**Updated  
Appendix G.  
Distribution Need Analysis**

# DISTRIBUTION SUBSTATION NEED ANALYSIS – PASO ROBLES DPA

Figure 6. Comparison of LoadSEER Forecasts, Paso Robles DPA<sup>6</sup>

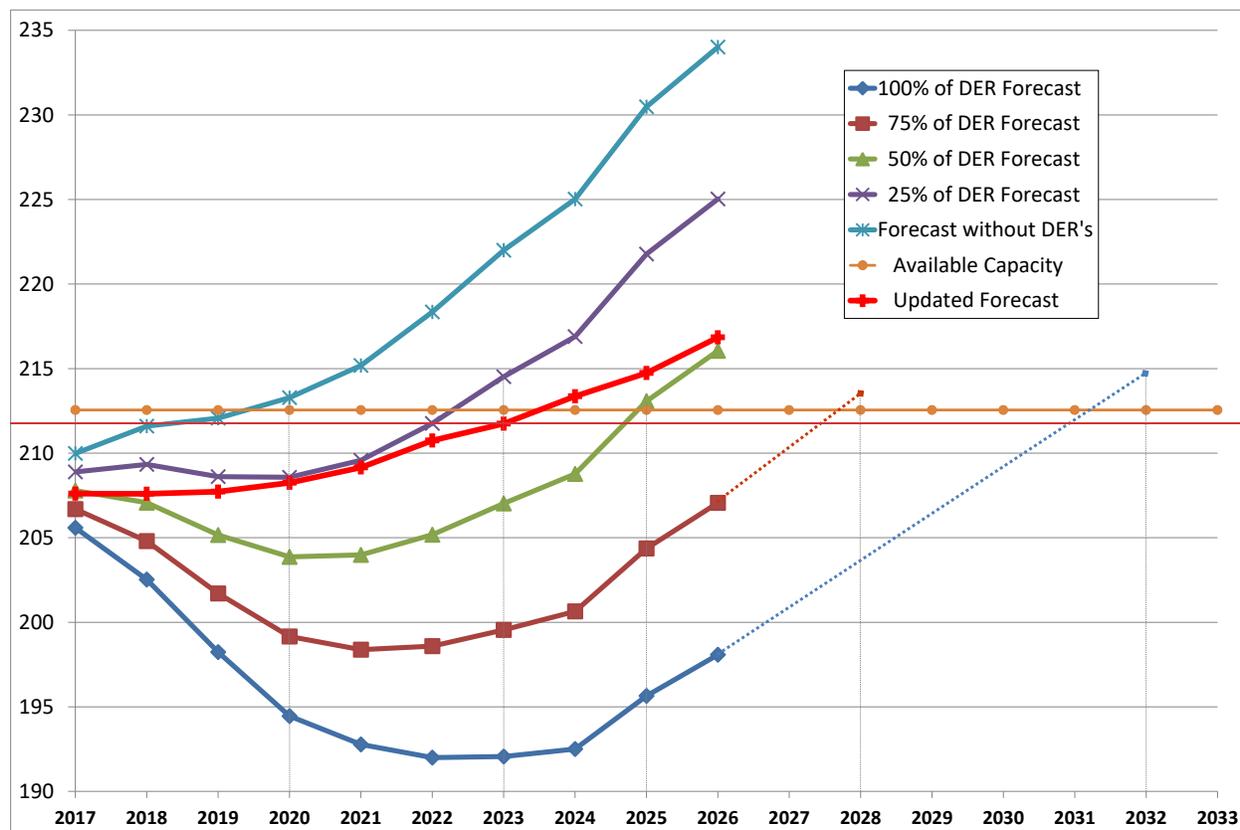
<sup>6</sup> Figure 6 is no longer relevant to the LoadSEER forecast, except for the 100% DER plot, but it is being provided at the request of the CPUC. The first five forecasts in Figure 6 used the previous 1-in-10 LoadSEER forecast for the Paso Robles DPA and then incorporated 100%, 75%, 50%, 25%, and none of the DER forecast estimates in PG&E's 2015 Distribution Resource Plan (DRP). The forecasts using 25% and none of the DER forecast estimated when available capacity would be reached by following a rough trajectory based on the last 3 points in each projection. (See also Table 5, which provides the data numerically.) The updated forecast in Figure 6 follows the CPUC's ruling of August 9, 2017, concerning how utilities should integrate DER growth scenarios into their distribution planning forecasts in order to better determine the need and timing for new distribution projects. (See also Table 5, which provides the data numerically.) The CPUC has directed utilities to use the 100% DER forecast based on the currently approved IEPR.

**Figure 7A. Future Estrella Substation Distribution System, Large Load Adjustments**

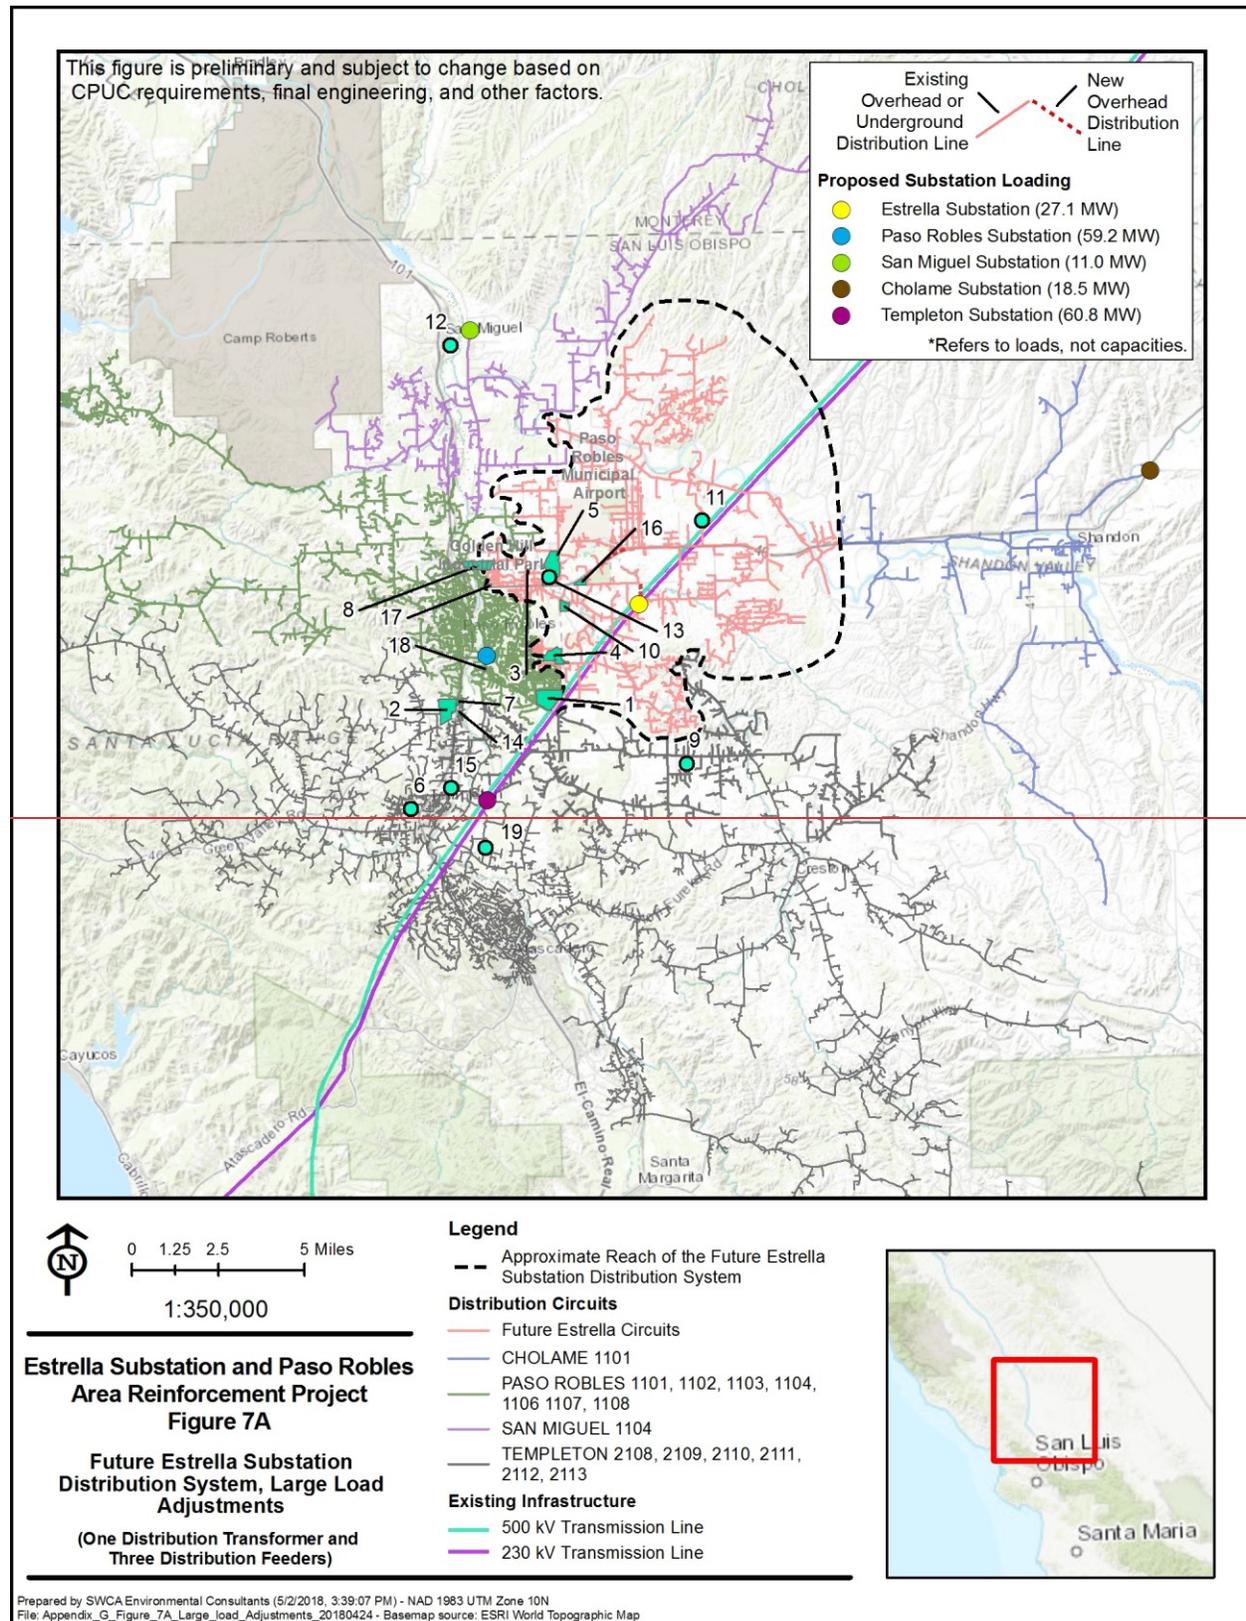
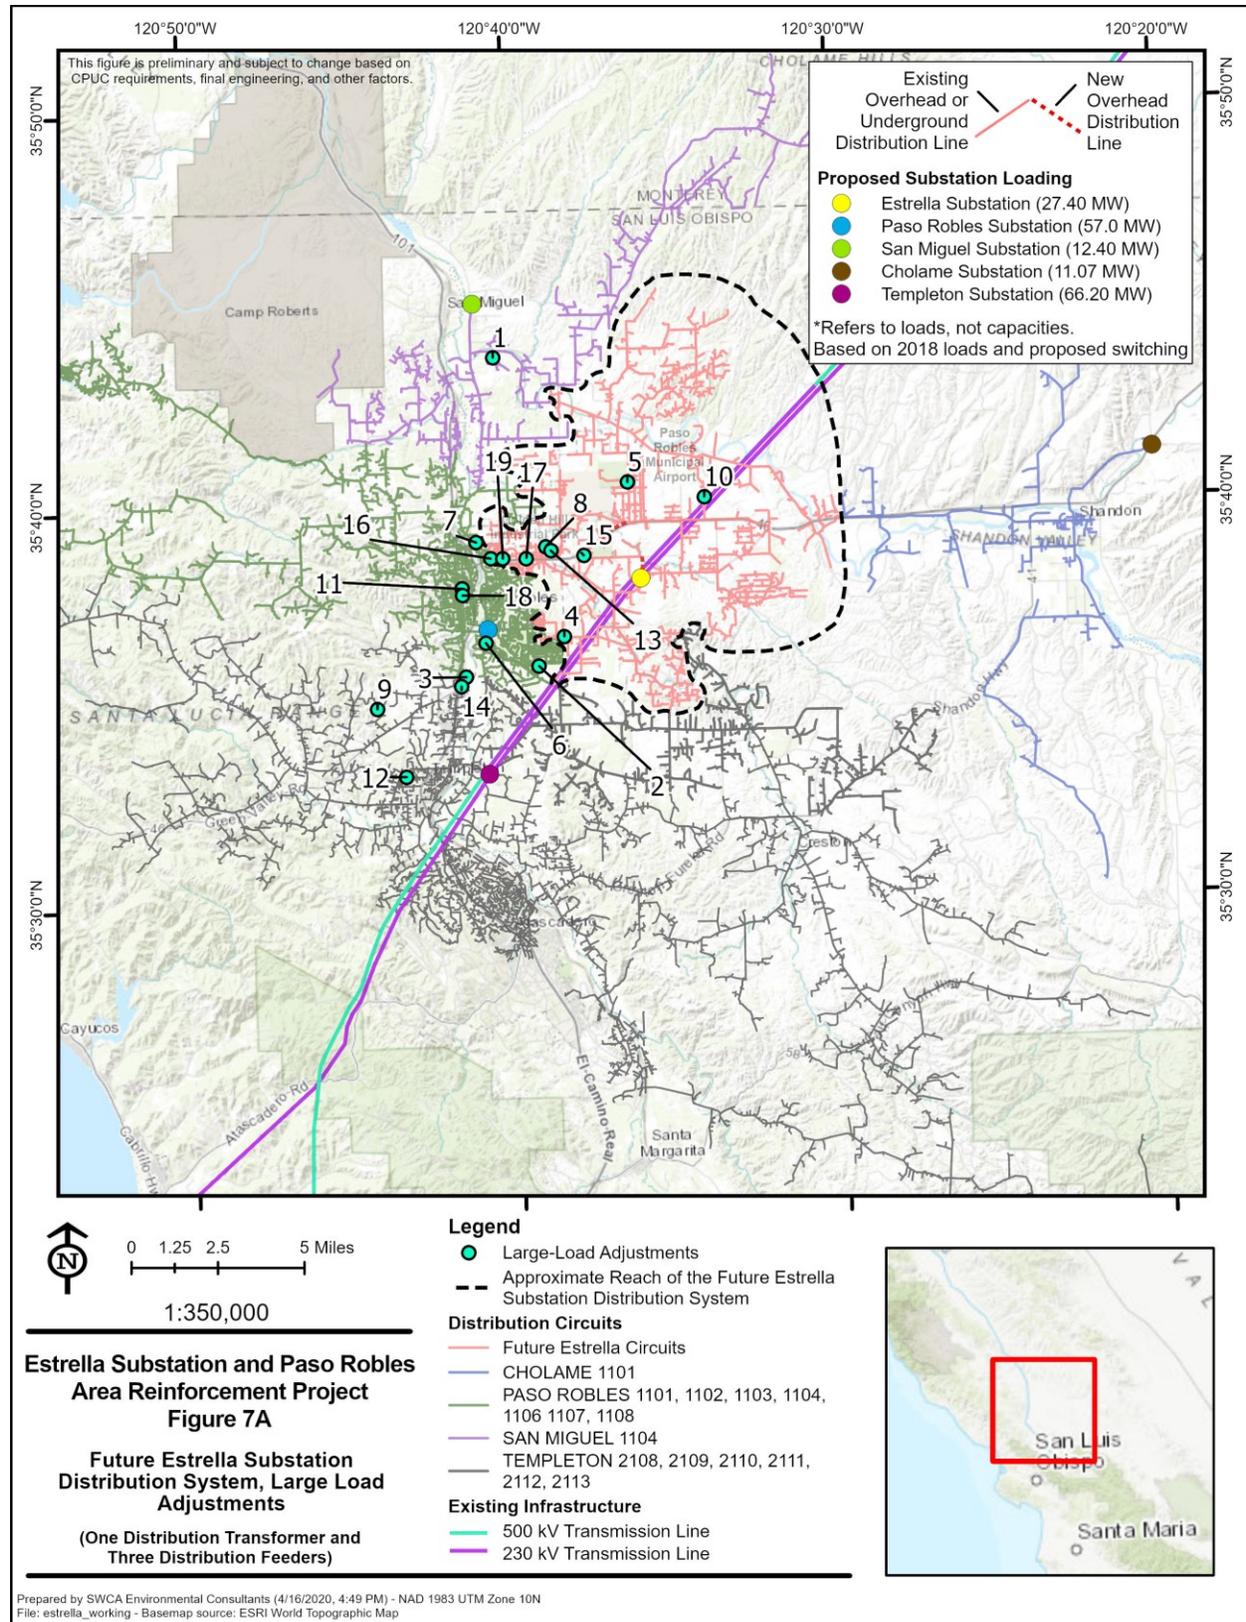
<sup>7</sup> Earlier versions of Figure 7 mislabeled Other Future Proposed Projects as Future Load Centers. While there is overlap, they are not the same and that error has now been corrected. Several Other Future Proposed Projects were removed in the January 2018 version of Figure 7 in order to eliminate duplications with Large-Load Adjustments (Figure 7A) and solar projects, projects unrelated to the future Estrella Distribution System, and projects for which there was no information. All but the duplicate projects have been added back into the current version, and others have been added based on new information.

\* The location of this project could not be identified and is thus not shown in Figure 7A.

**Figure 7B. Future Estrella Substation Distribution System, Other Future Proposed Projects**

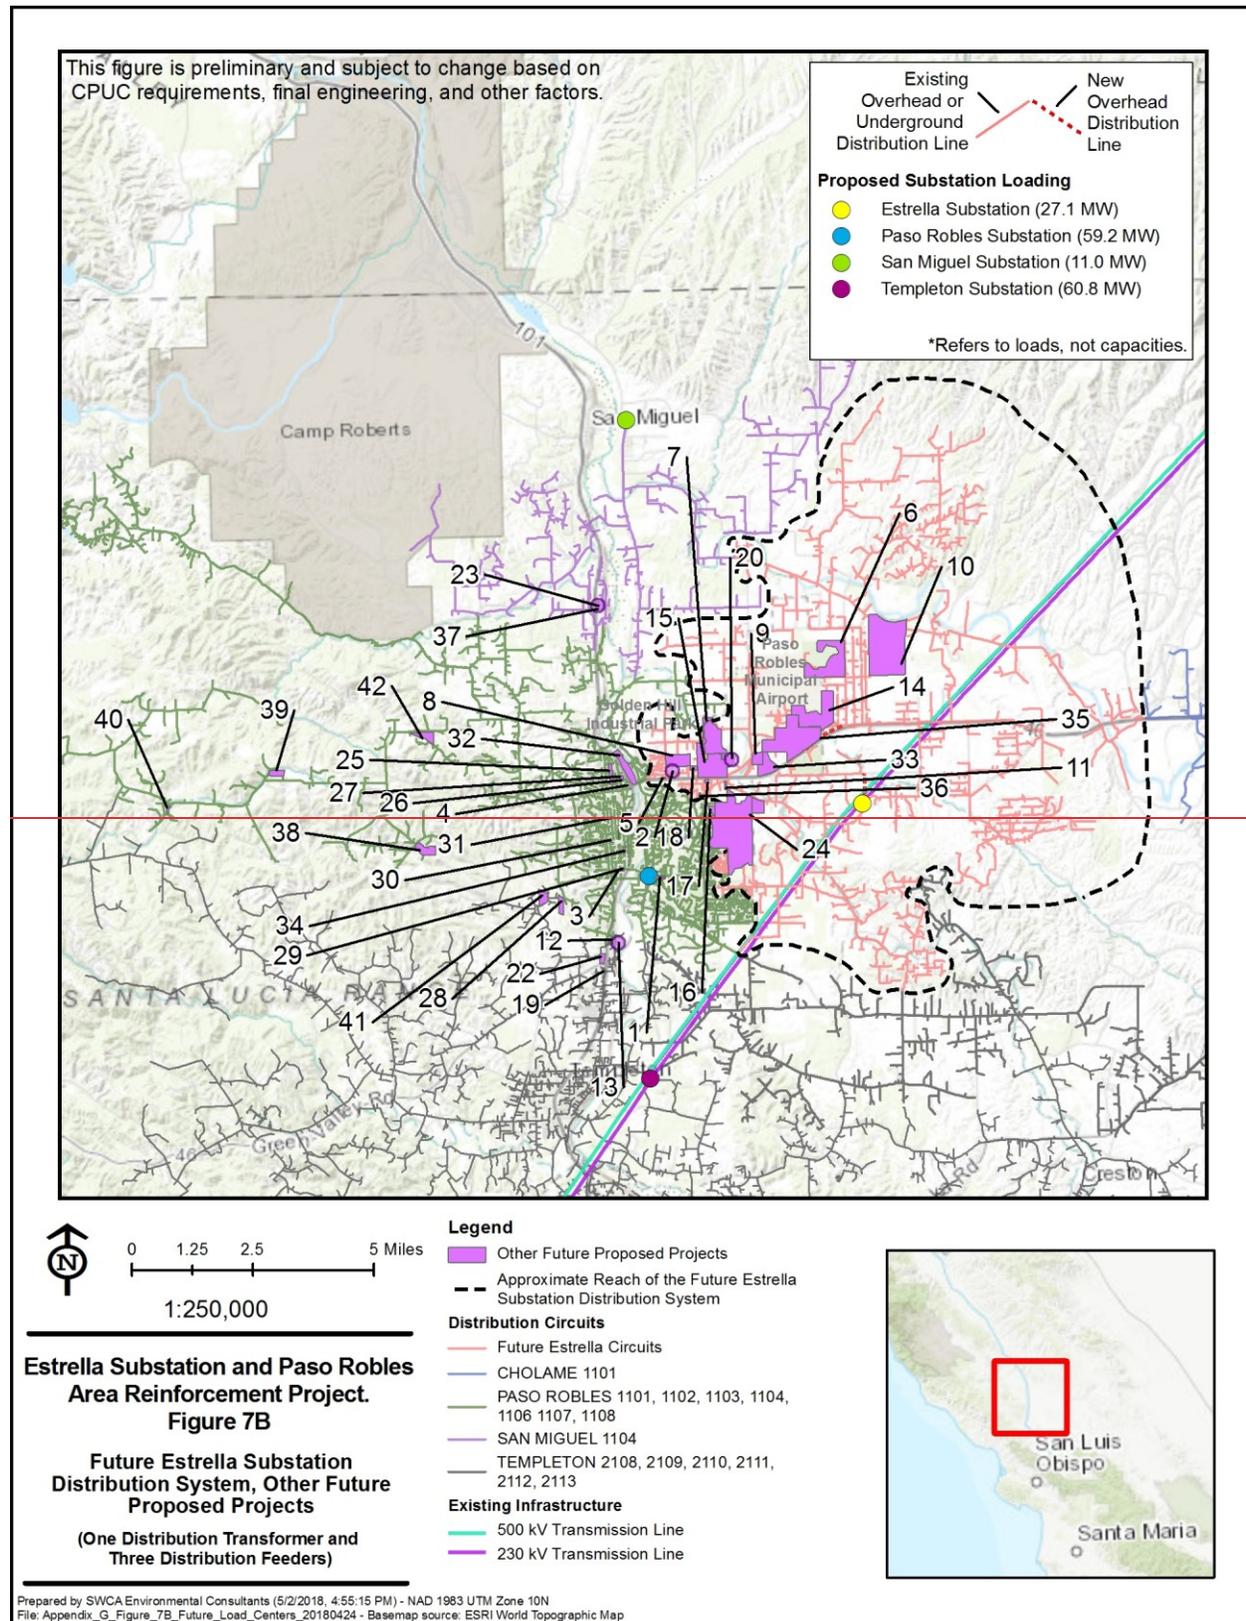
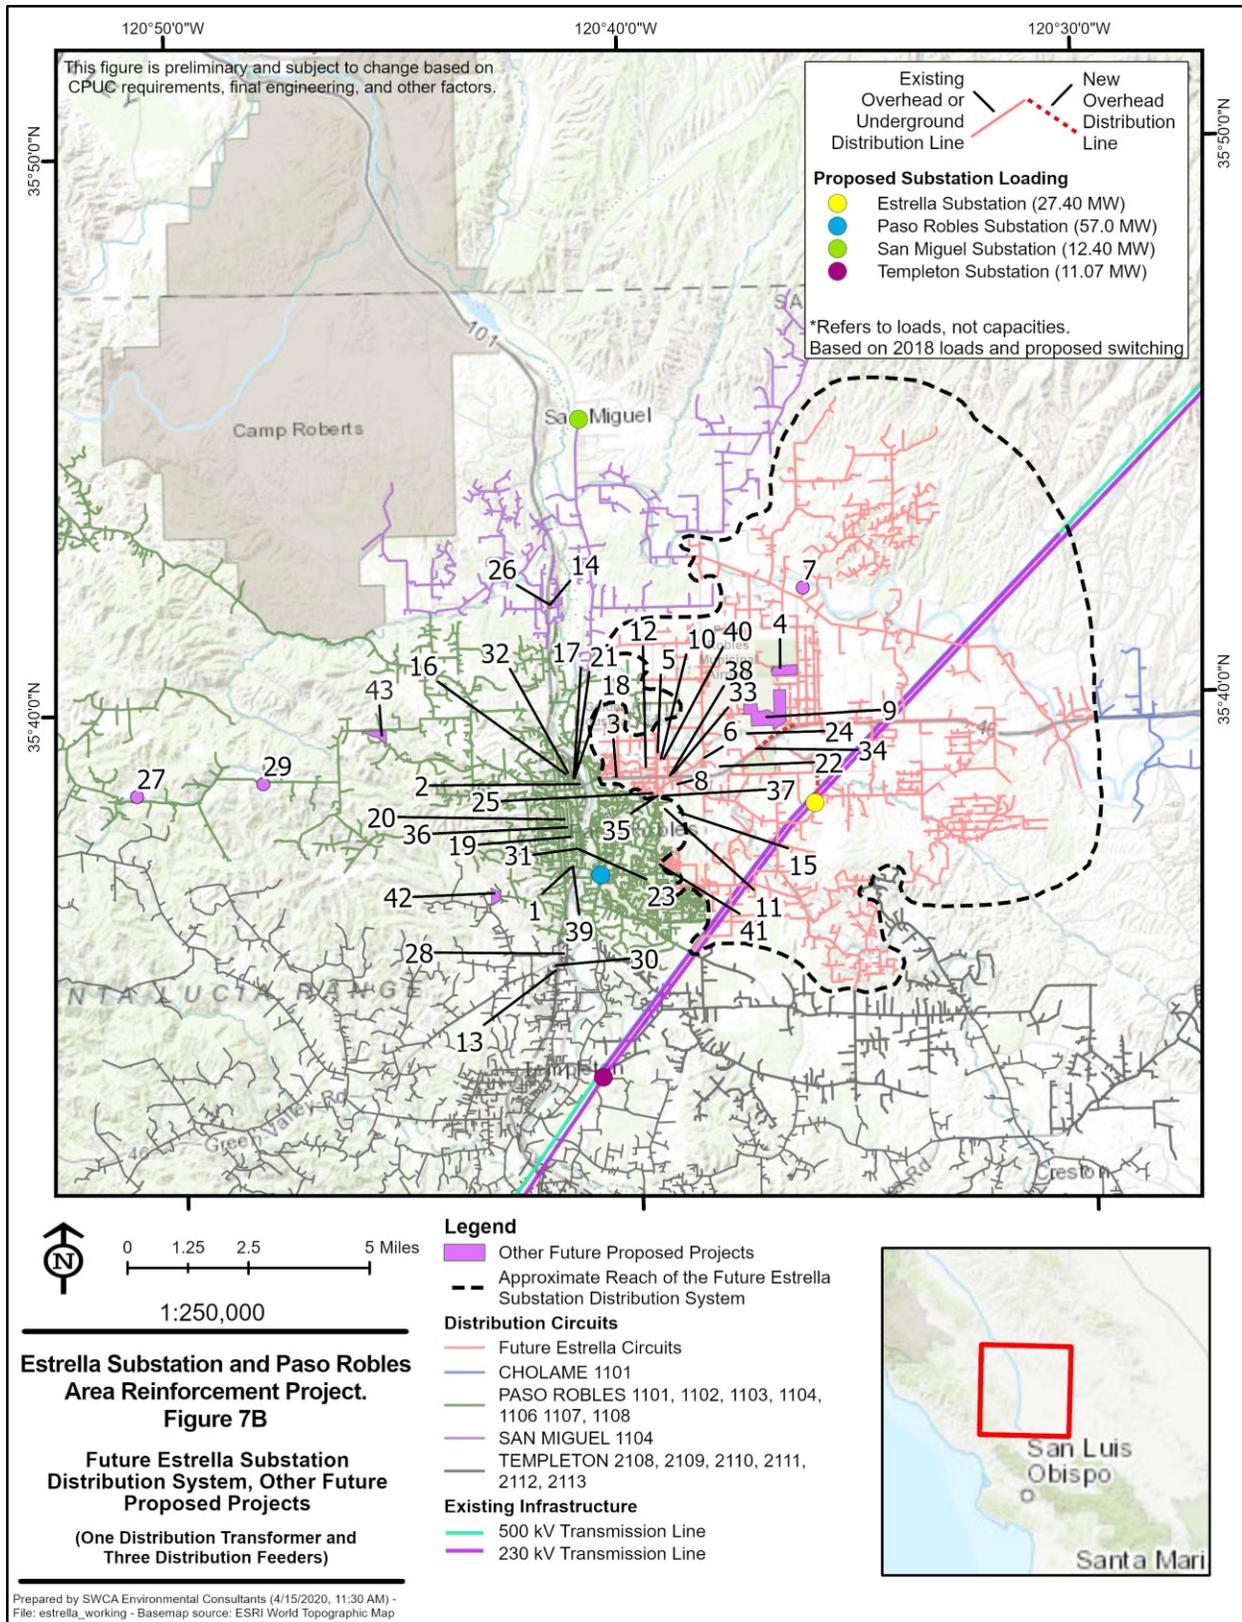
\* The location of this project could not be identified and is thus not shown in Figure 7B.
